PRODUCT / PROCESS CHANGE NOTIFICATION

PCN-000839

Date: JUN-08-2023

Change Details							
Part Number(s) Affected: Please see the next page for a list of affected part numbers.	Customer Part Number(s) Affected: <input checked="" type="checkbox"/> N/A						
Description, Purpose and Effect of Change: DUAL SOURCING Semtech has qualified Greatek in Taiwan as a second assembly source for the affected part numbers listed on the following page. This change applies to 16MLPQ 4x4mm and 32MLPQ 5x5mm packages, currently assembled by UNSIEM(M) in Malaysia. Please see the following pages for comparisons on process flow, material, and equipment. Test platform and test programs are unchanged.							
<table border="1" style="margin: auto; border-collapse: collapse;"> <thead> <tr> <th style="padding: 5px;">Current assembly source</th> <th style="padding: 5px;">Secondary assembly source</th> </tr> </thead> <tbody> <tr> <td style="text-align: center; padding: 5px;">UNSIEM(M)</td> <td style="text-align: center; padding: 5px;">GREATEK</td> </tr> </tbody> </table>				Current assembly source	Secondary assembly source	UNSIEM(M)	GREATEK
Current assembly source	Secondary assembly source						
UNSIEM(M)	GR

Comparisons

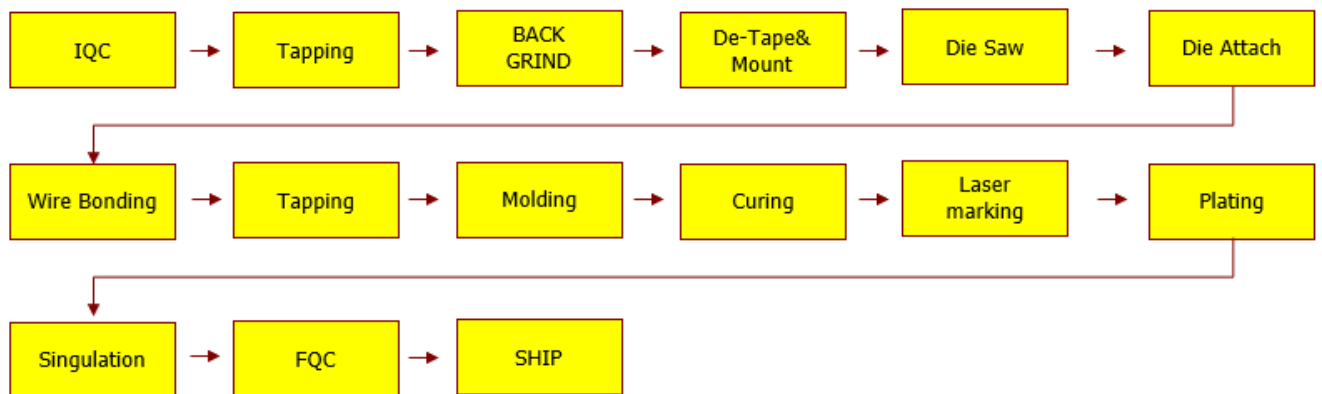
➤ MATERIAL

Material	UNSIEM(M)	GREATEK
Lead frame Material	Copper	Copper
Molding Compound	EMEG770HCD	Sumitomo G700H
D/A Epoxy	CRM1076NS	Sumitomo 1076DJ
Wire Material	Gold	Gold
